**Docket A-98-49
Item V-B2-1**

**COMPLIANCE APPLICATION REVIEW DOCUMENTS
FOR THE CRITERIA FOR THE CERTIFICATION
AND RECERTIFICATION OF THE
WASTE ISOLATION PILOT PLANT'S
COMPLIANCE WITH THE
40 CFR PART 191 DISPOSAL REGULATIONS:
FINAL RECERTIFICATION DECISION**

**U.S. Environmental Protection Agency
Office of Radiation and Indoor Air
Washington, D.C. 20460**

March 2006

Figure 15-3. Locations of Culebra well tests.

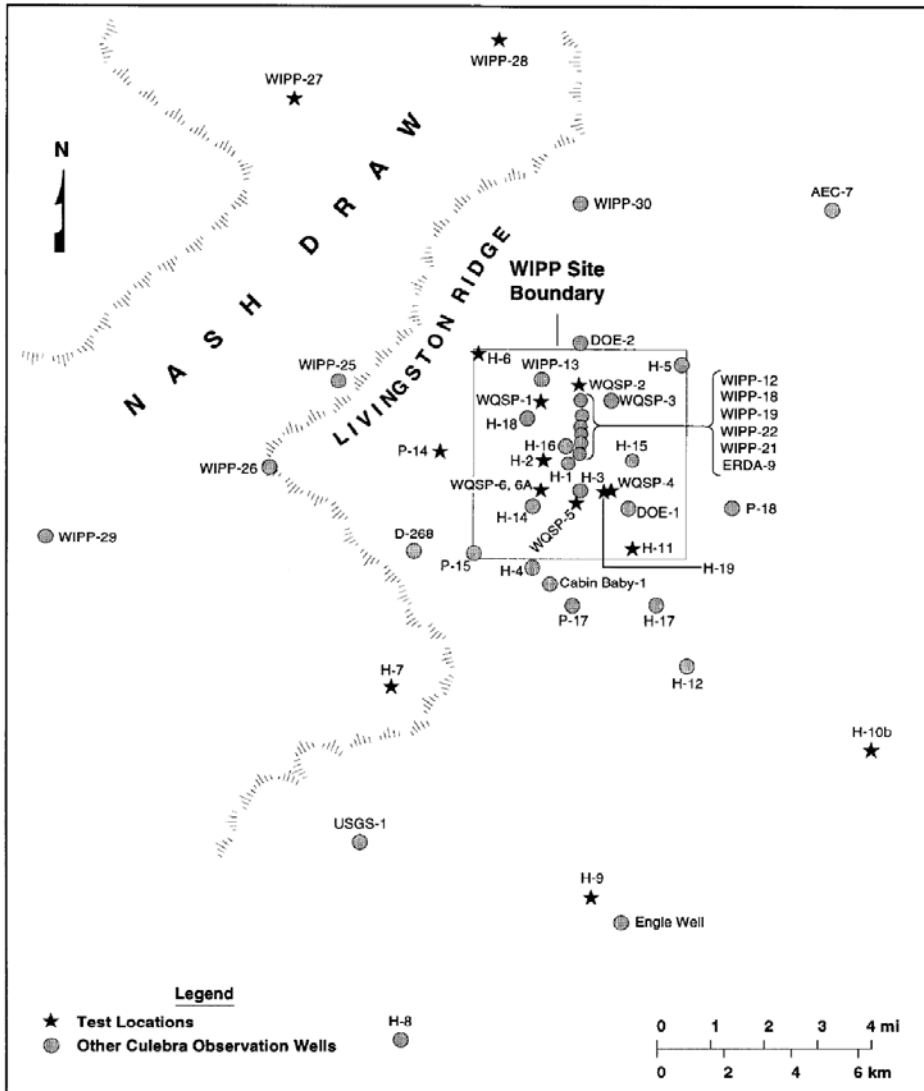
DOE has studied the WIPP site and vicinity for over thirty years (see Figure 15-3 for locations of Culebra well tests). New data is collected annually. In addition to the geologic studies, numerous pump test tests have been done, including large scale pumping tests (e.g., Beauheim and Ruskauff, 1998) and other analyses. DOE has provided these data and analysis results in the 2004 CRA and other reports. These data and their analyses provide information over large areas and form the basis for the performance assessment modeling and much of the discussion presented here. For example, in the 2004 CRA, DOE identified that the Culebra transmissivity is a function of overburden thickness—the deeper the Culebra, the lower the transmissivity (2004 CRA, Appendix PA, Attachment TFIELD). Superimposed on the depth are geologic factors such as the location relative to the margin of upper Salado dissolution and to halite in the M3/H3 interval of the Tamarisk.

The Magenta and Culebra appear to have little real-time connection to one another as claimed by some commenters. Numerous pumping tests show that the Magenta and Culebra are independent of one another (Beauheim and Ruskauff, 1998; Meigs et al, 2000; 2004 CRA Chapter 2, section 2.2.1.4.1.2). Pump tests in the Culebra elicit no response from the Magenta. Even at WIPP-25 in Nash Draw, a pumping test conducted in 2004 indicates that the Magenta and Culebra are hydraulically isolated from one another (Lorenz, 2005, p. 63). This is typical for all pump tests performed. In addition water chemistry differences also point to lack of connections between the two units.

Figure 15-4. Four Hydrochemical Facies in the Culebra Siegel et al. 1991

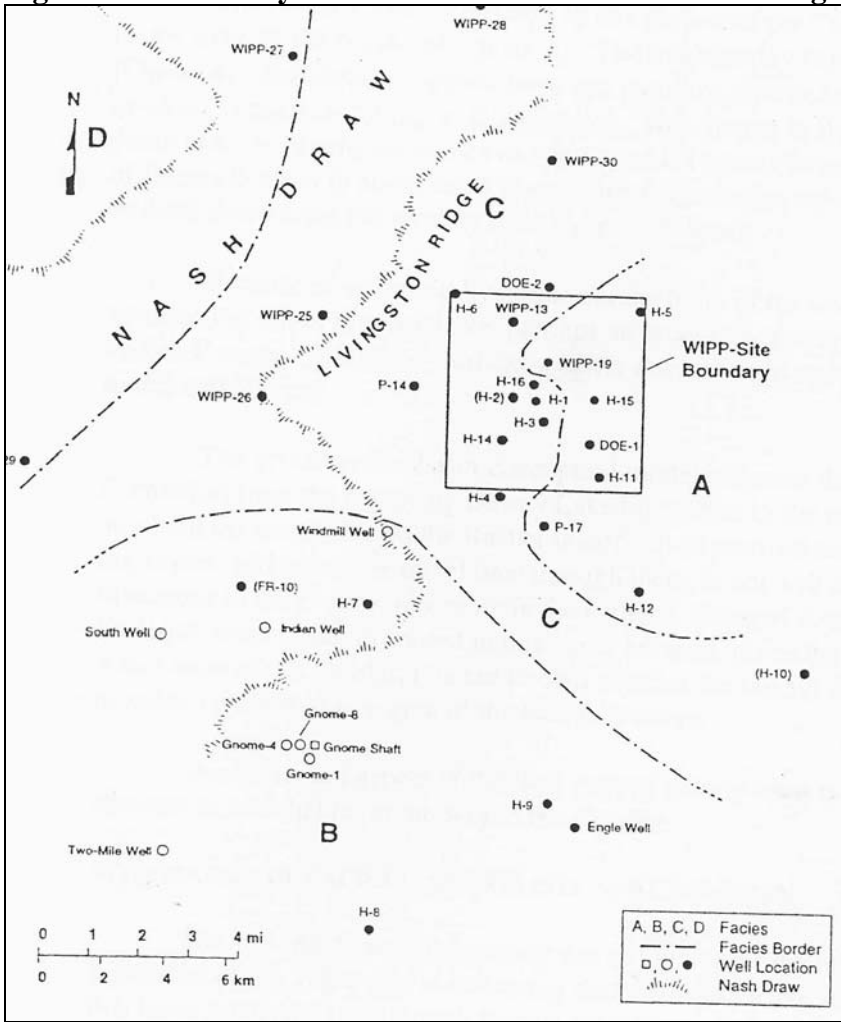
In the ground water basin model, the eastern part of the system is characterized by extremely slow horizontal and vertical flow, with high salinity (Facies A) (Figure 15-4). In the middle of the WIPP site (Facies C), the lateral flow is slightly faster, but still slow. Corbet (1997) estimates that it would take 20,000 years for water to flow across the WIPP site in Facies C. Vertical flow (specific discharge) would be 0.01 to 0.03 m/1000 years. The water in both facies have had long residence times and interacted with the anhydrite and halite in the system, thus reducing their reactivity and ability to dissolve rock under current climate or in the last several thousand years. Limited age dating of water at the WIPP site also indicates that the Culebra water is old (2004 CRA, Chapter 2, section 2.2.1.4.1.2). Flow is driven by recharge to the system over 8,000 years ago, especially greater than 14,000 years ago, during glacial times and the system is still equilibrating to that climate regime. The model indicates that only about 2 mm/yr recharge is necessary to produce the flow that we see today. This corresponds well to the research on recharge that shows it to be limited (Campbell et al, 1996; Hogan et al, 2004) in the WIPP region.

EPA believes that, on a regional scale, the groundwater basin model done by DOE reasonably predicts the current ground water flow regime and the geochemistry of the site.

Figure 34.1. Mean and Quantile CCDFs for Total Normalized Releases: All Replicates of the CRA-2004 PABC (from Figure 6-4, 2004 Compliance Recertification Application Performance Assessment Baseline Calculation, Docket A-98-49, Item B2-51)

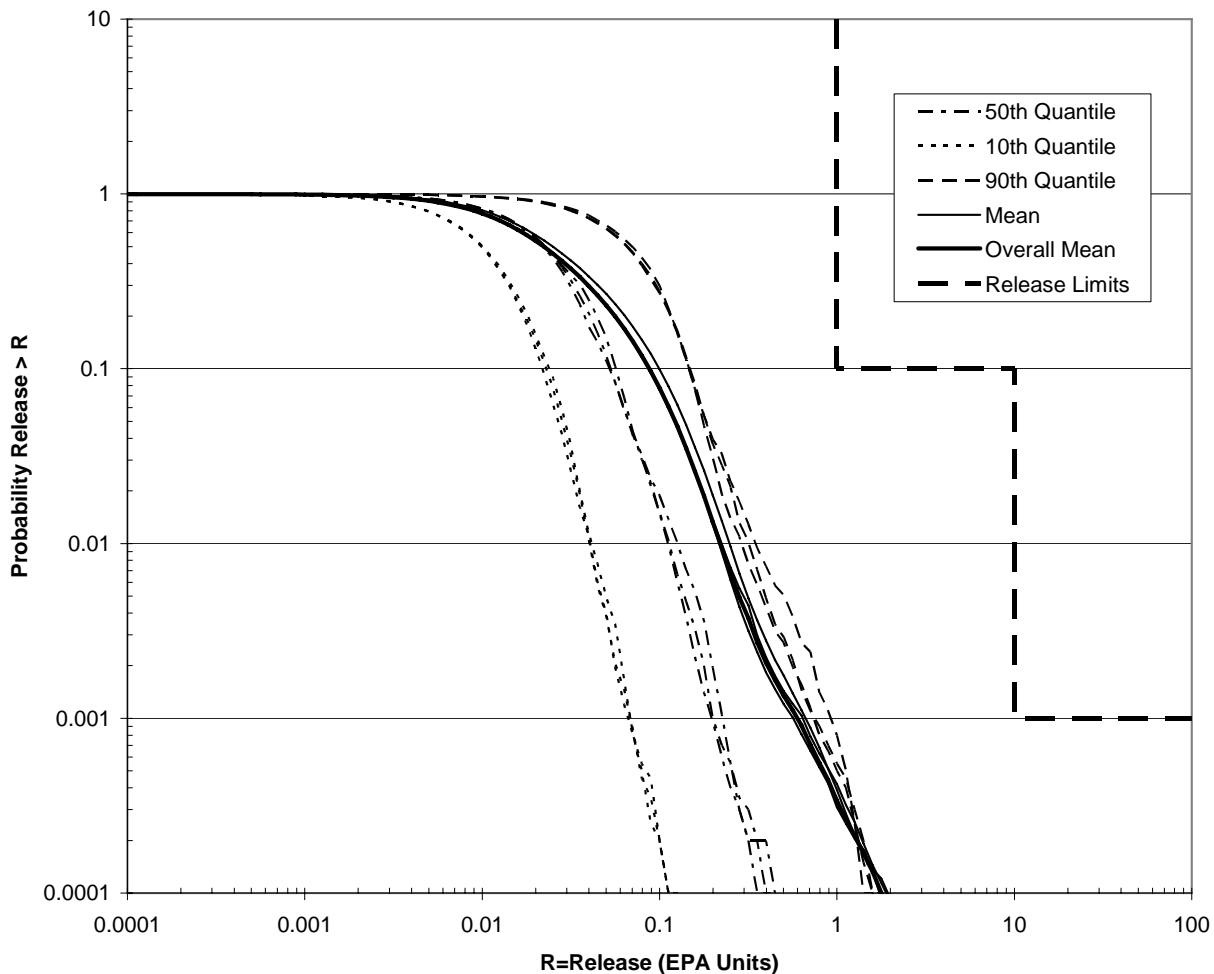
DOE used selected computer codes and input parameters to generate estimates of radionuclides for a large number of release scenarios. In total, 300 CCDFs (100 for each of the three replicates) were constructed and presented in the Performance Assessment Baseline Calculation Report (Docket A-98-49, Item II-B2-60) for total normalized releases (Figure 34-1). Three hundred realizations were needed in order to satisfy the requirements of Section 194.34(d). Normalized release results for ten thousand future simulations were used to calculate each of the 300 CCDF curves. In addition, DOE provided CCDFs for individual pathways and by replicate. EPA's analysis (Docket A-98-49, Item II-B1-16) concluded that DOE adequately presented the PA results in CCDFs, which show the probability of exceeding various levels of cumulative releases.

Figure 34-2. Total Normalized Releases for 100 CCDFs of Replicate R1 of the CRA-2004 PABC (Figure 6-1, PABC Report, Docket A-98-49, Item II-B2-60).

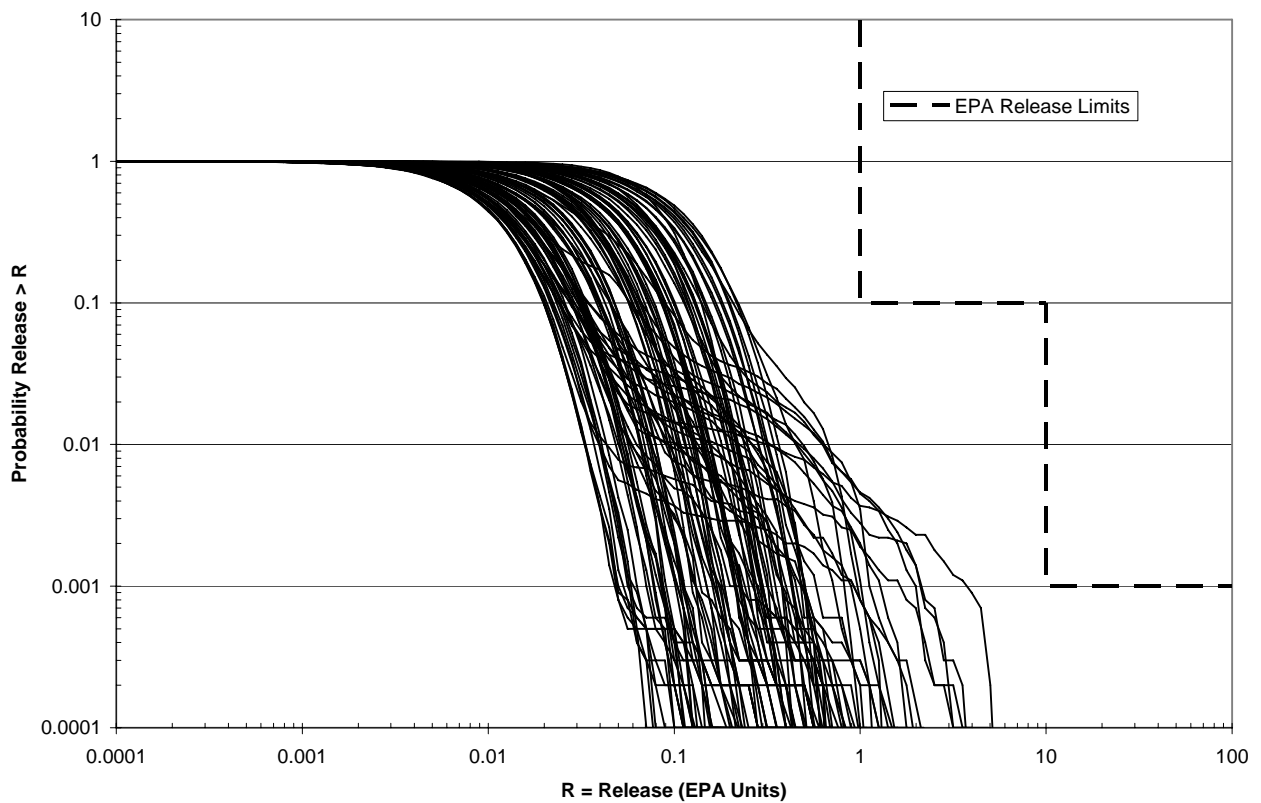
DOE presented and discussed the results of the performance assessment analysis in the 2004 CRA, Chapter 6 and the PABC report, Chapter 6 (Docket A-98-49, Item II-B2-60). Figure 34-2 shows the releases from replicate R1 of the CRA-2004 PABC.

Based on a review and evaluation of the 2004 CRA and supplemental information provided by DOE (FDMS Docket ID No. EPA-HQ-OAR-2004-0025, Air Docket A-98-49) and the fact that DOE included the full range of CCDFs as required by this section, EPA determines that DOE continues to comply with the requirements for Section 194.34(e).
